645-017-11

ADDENDUM NO. 2

Wayne State College
Carhart Building Phase III
Wayne, NE
TCEP No.: 645-017-11

Addendum #02
 Supplemental Drawing: SDA-003
 Revision of Detail: 12/A7.1
 Date: April 9, 2012

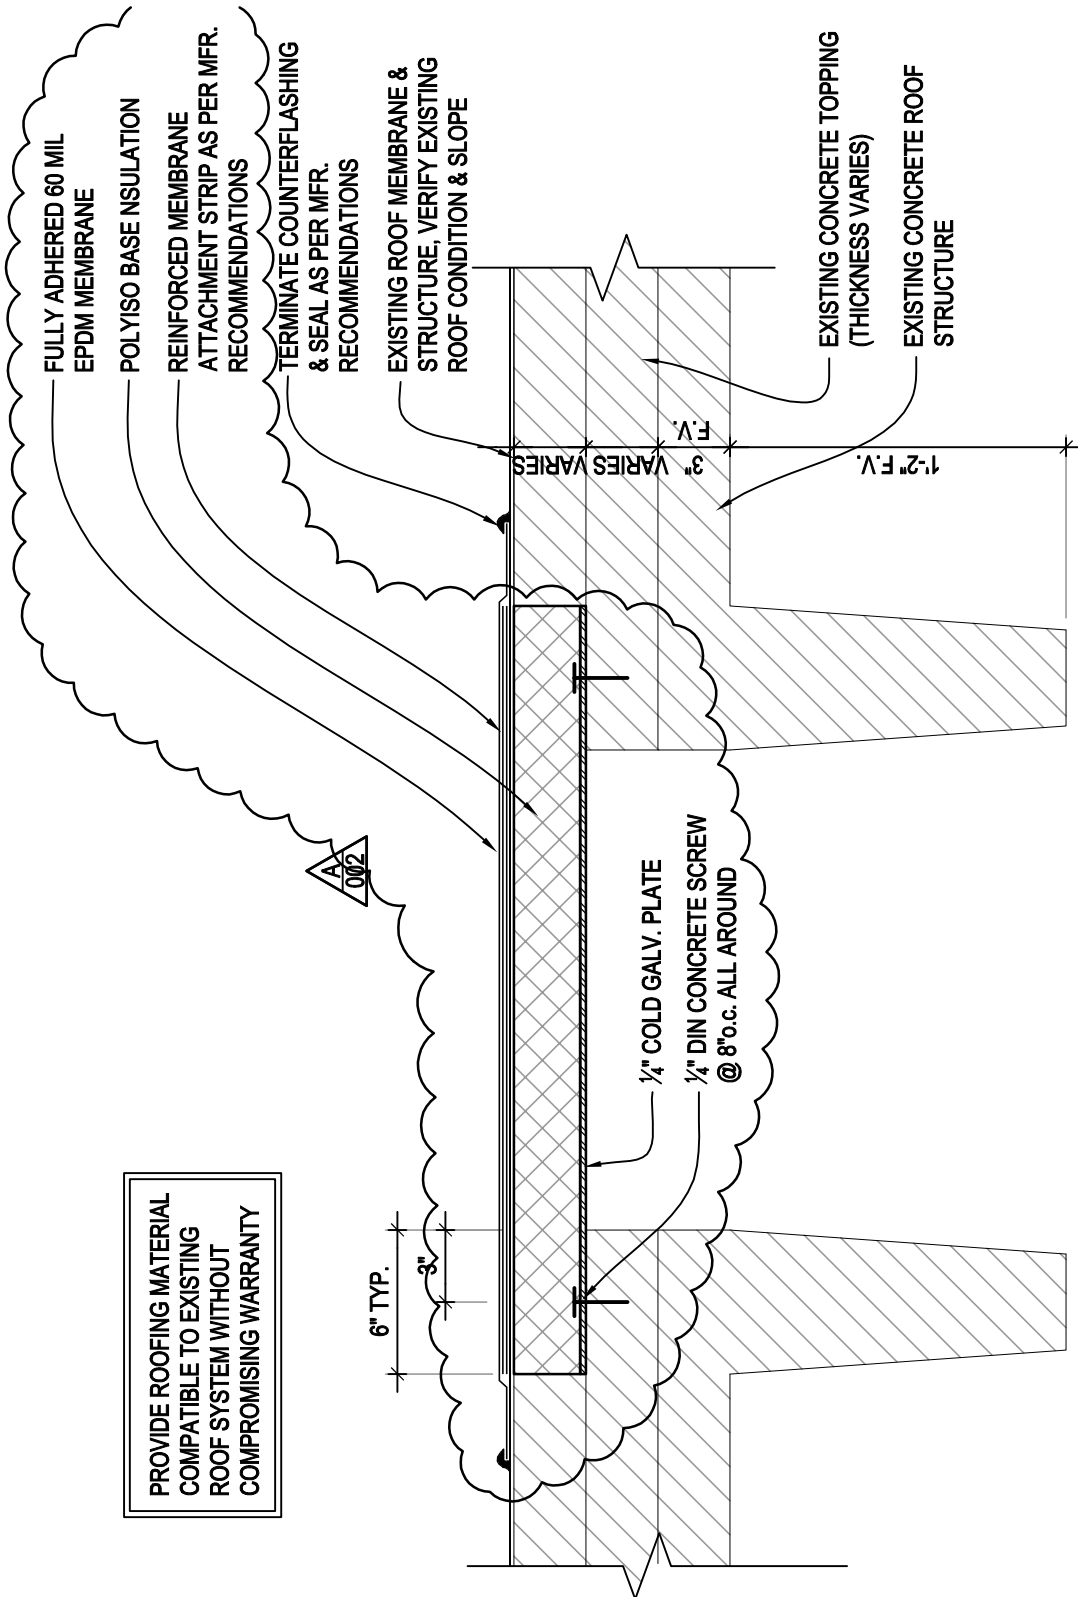
Modify Detail 12/A7.1 See supplemental drawing SDA-003.

Addendum #02
Supplemental Drawing: SDA-004
Revision of Detail: 16/A7.1
Date: April 9, 2012

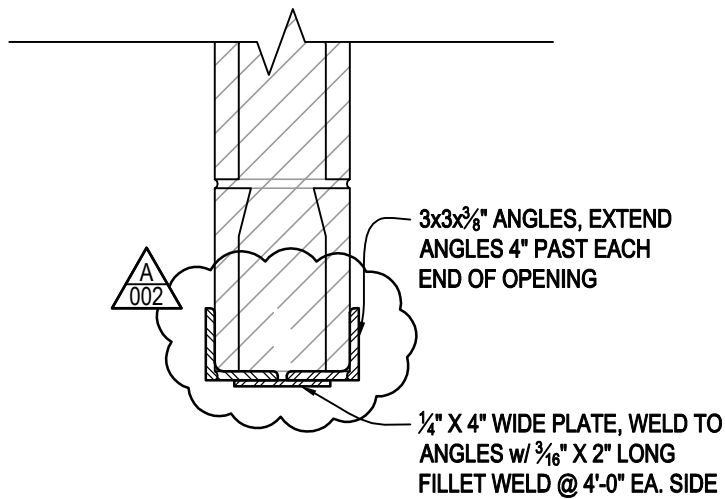
Modify Detail 16/A7.1 See supplemental drawing SDA-004.

Addendum #02
Supplemental Drawing: SDA-005
New Detail: 11A/A8.1
Date: April 9, 2012

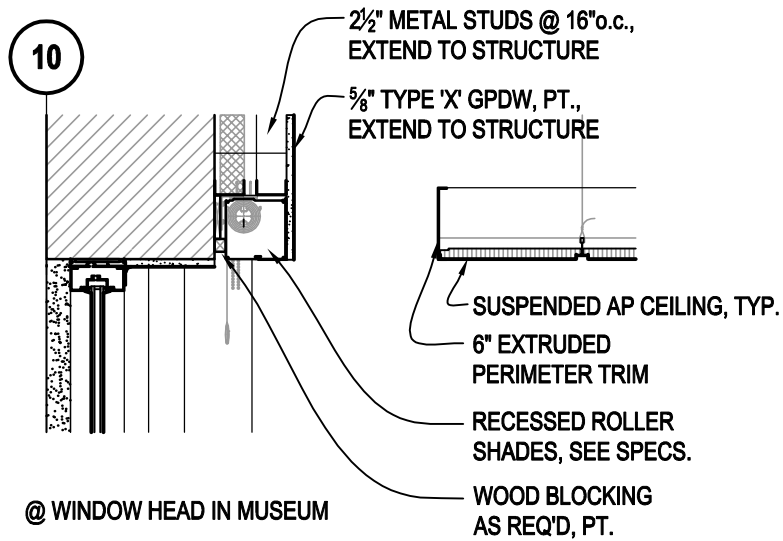
Wall Section shall read **11A/A6.1** not 1/A8.1. See supplemental drawing SDA-005.

Add Detail 11A/A8.1. See supplemental drawing SDA-005.

Addendum #02
Supplemental Drawing: SDA-006
Revision of Sheet: A0.1
Date: April 9, 2012

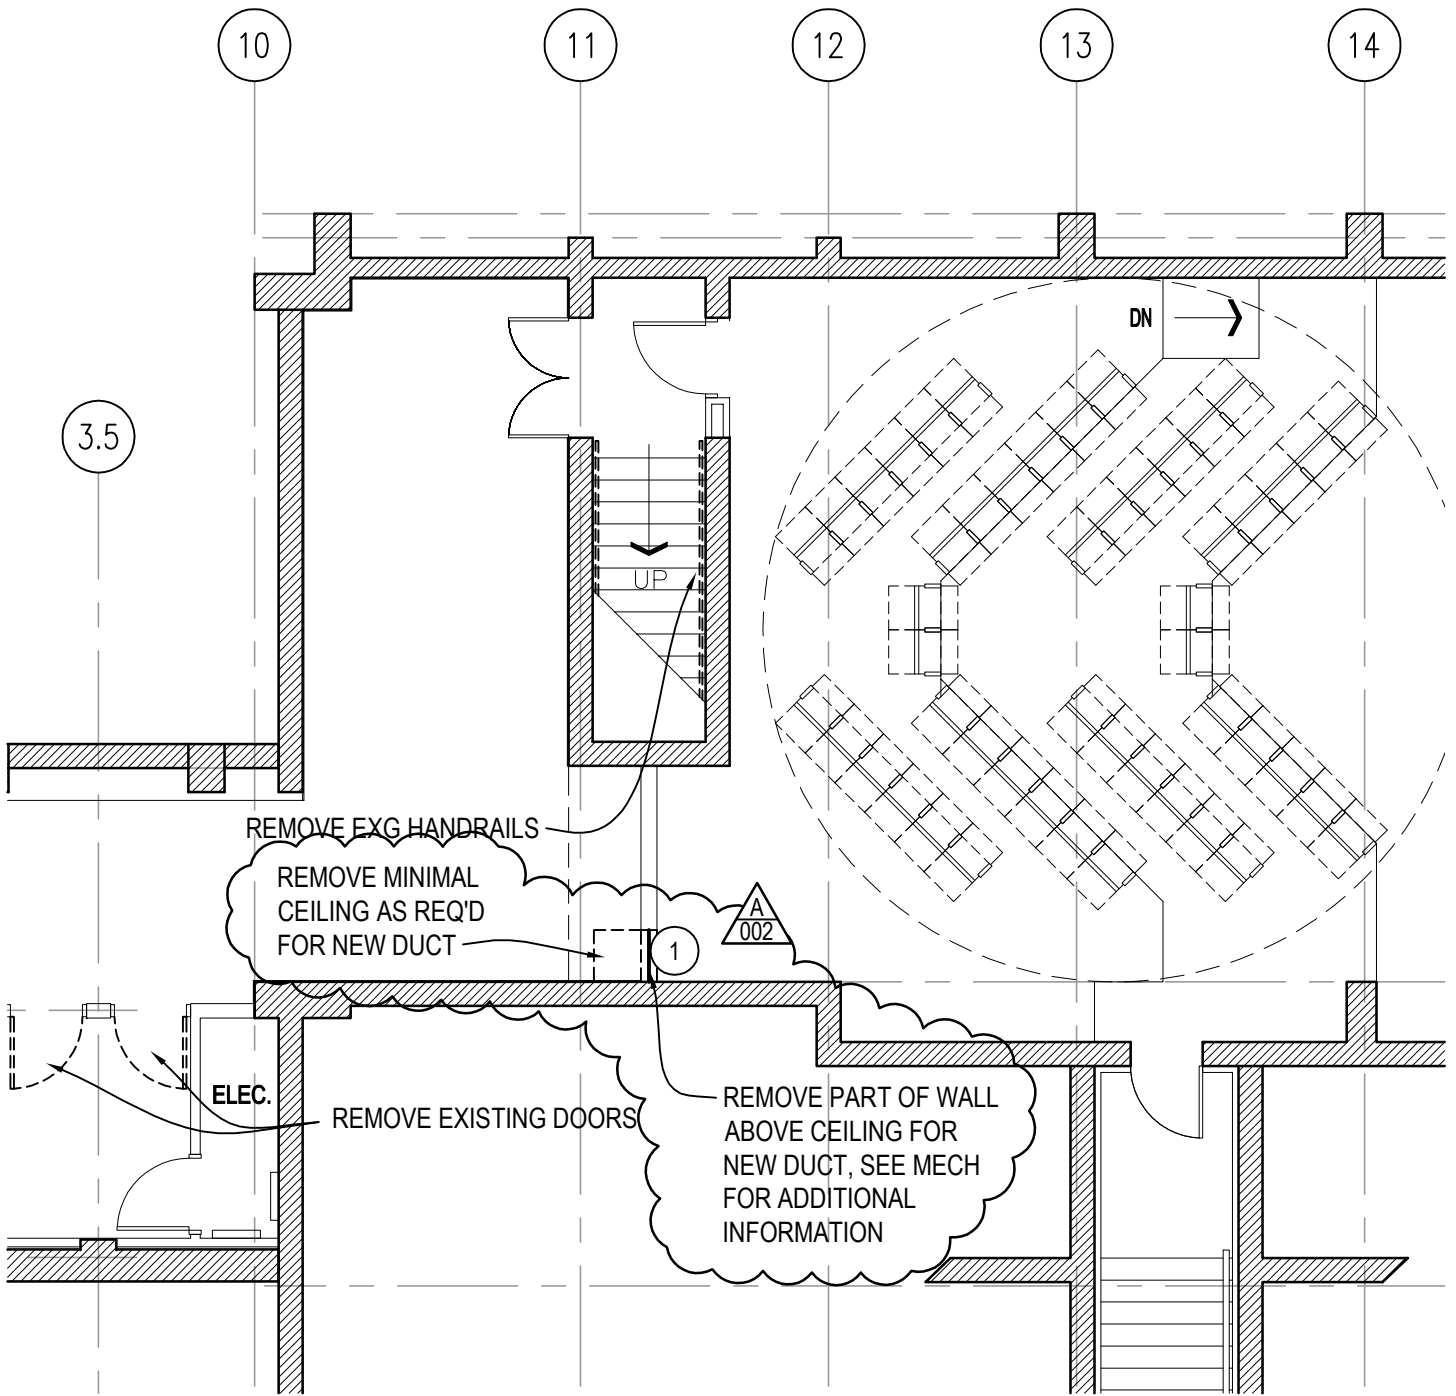
Add note, “**9 – VCT tile removal by demolition contractor.**”

See supplemental Drawing SDA-006.

Addendum #02
Supplemental Drawing: SDA-007B
Revision of Sheet: A0.2
Date: April 9, 2012

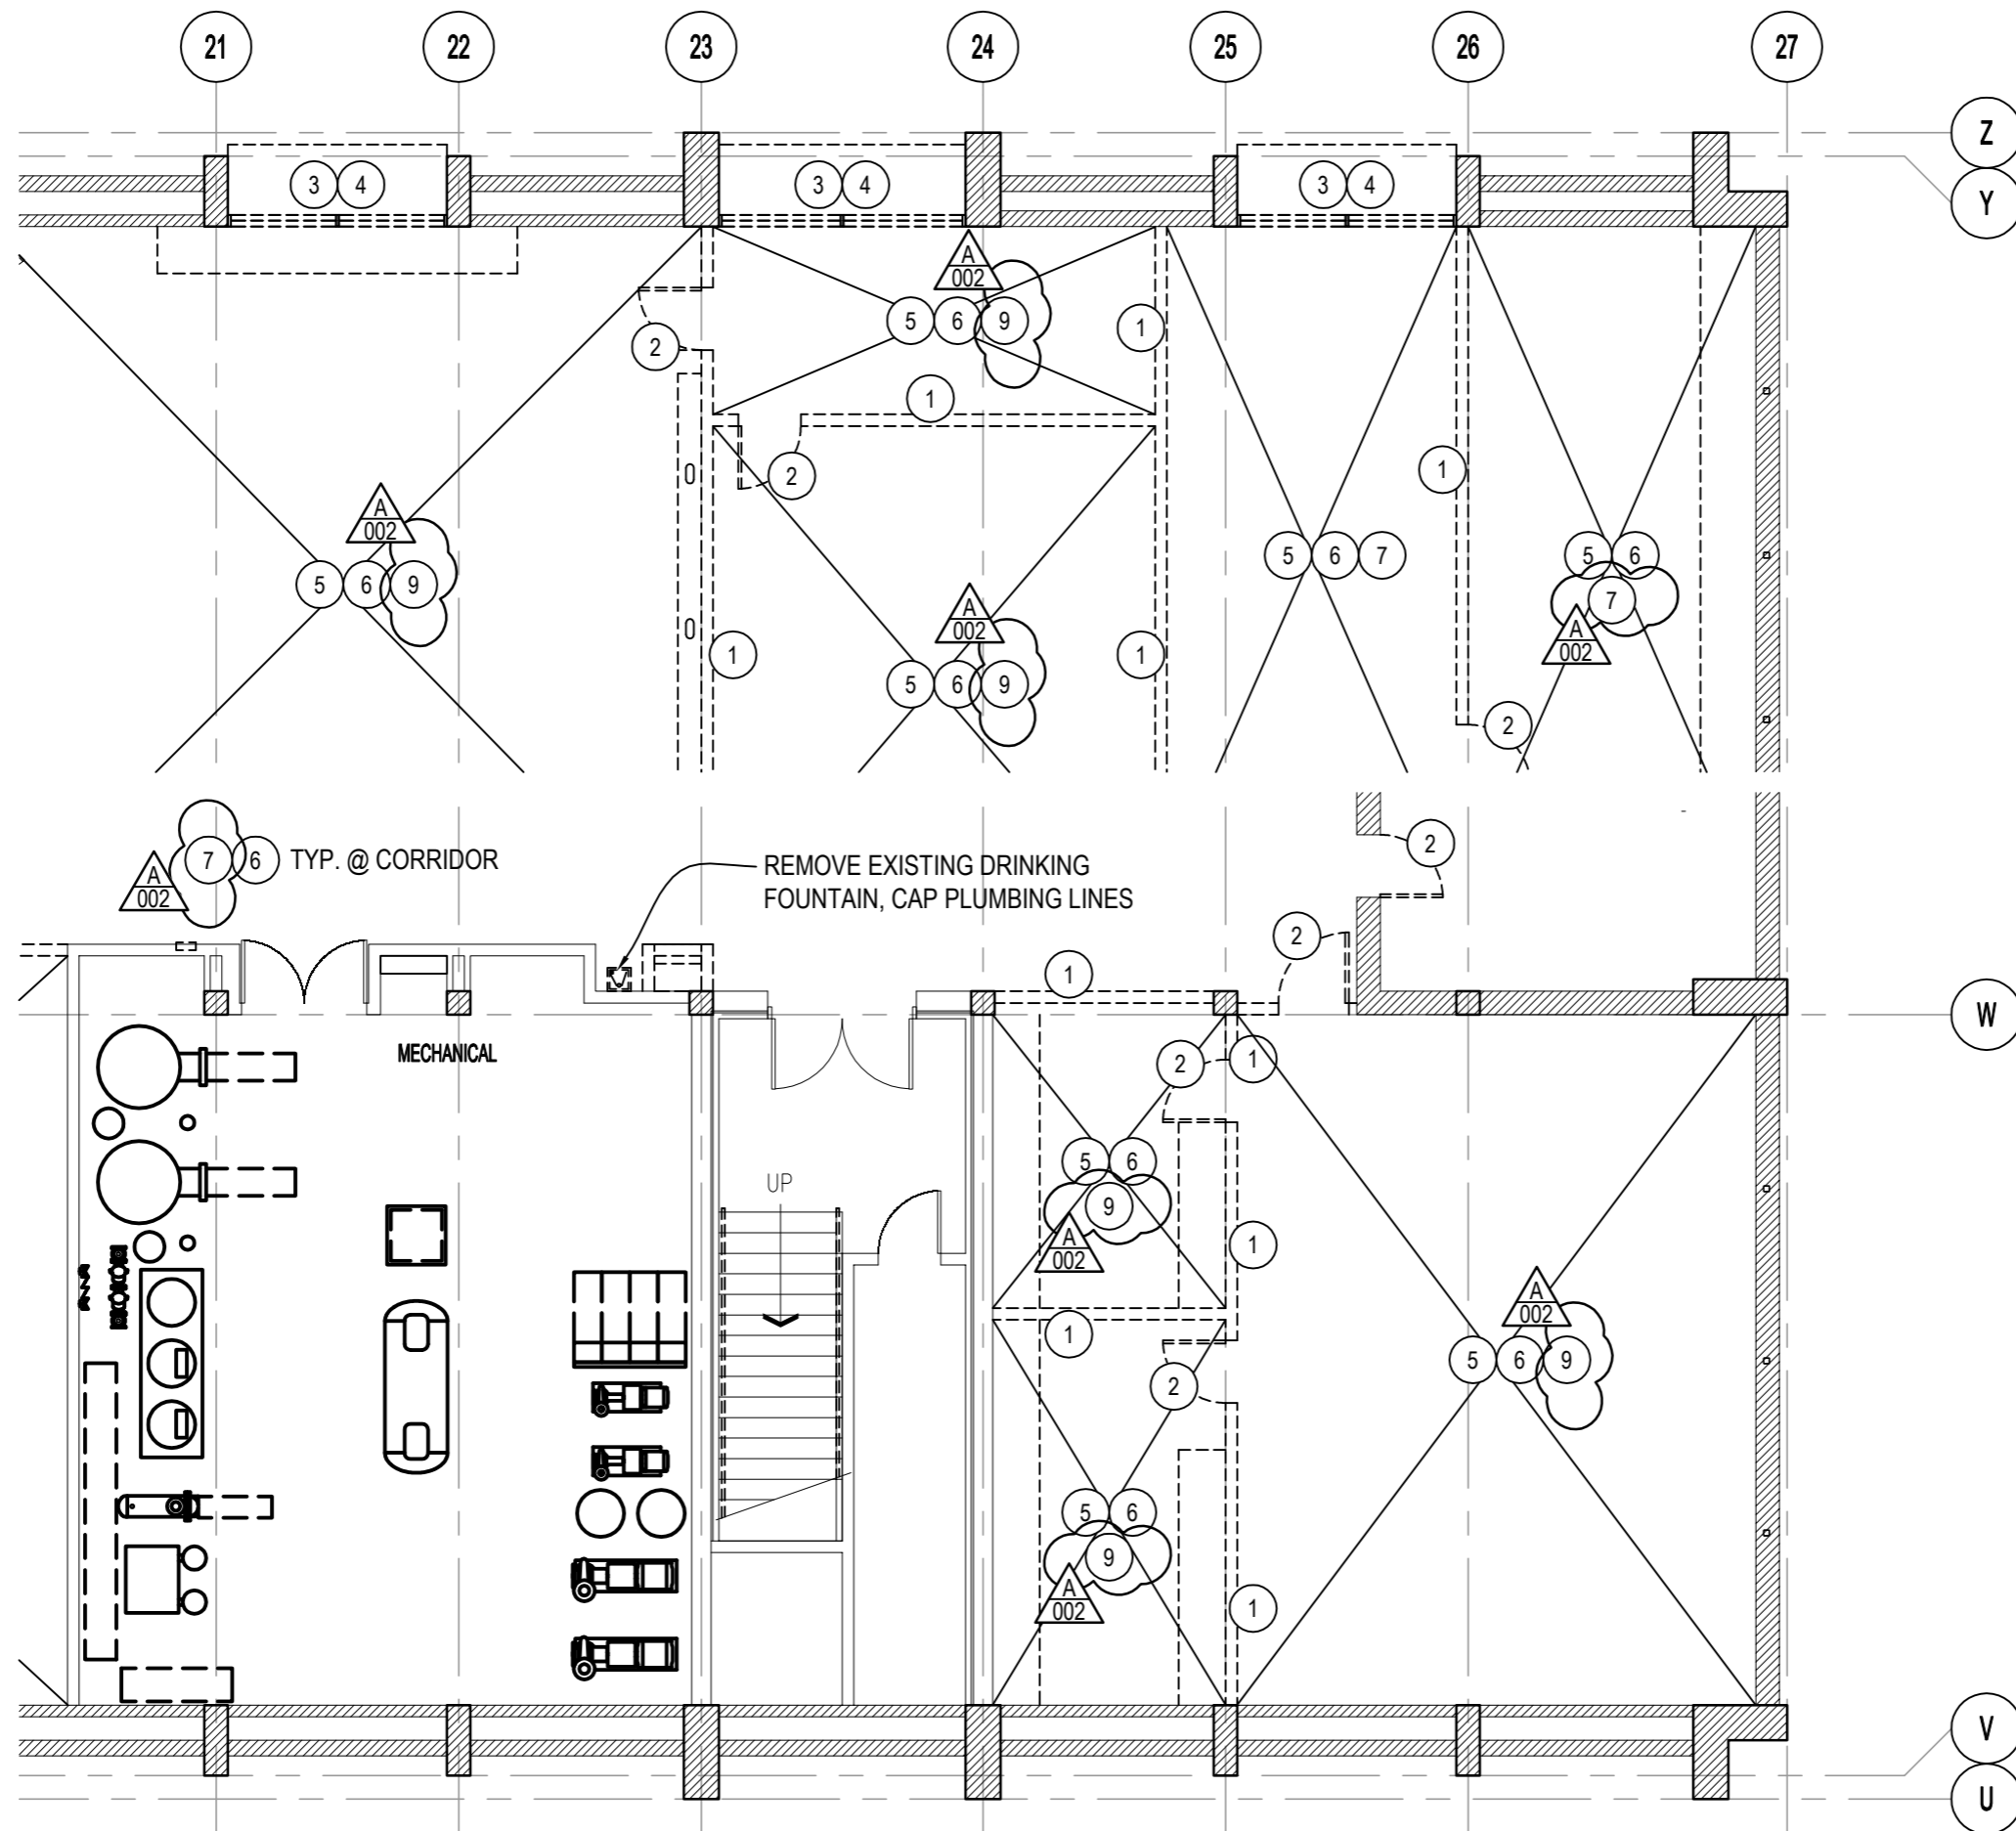
Add note, “**9 – VCT tile removal by demolition contractor.**”

See supplemental Drawing SDA-007A & SDA-007B.
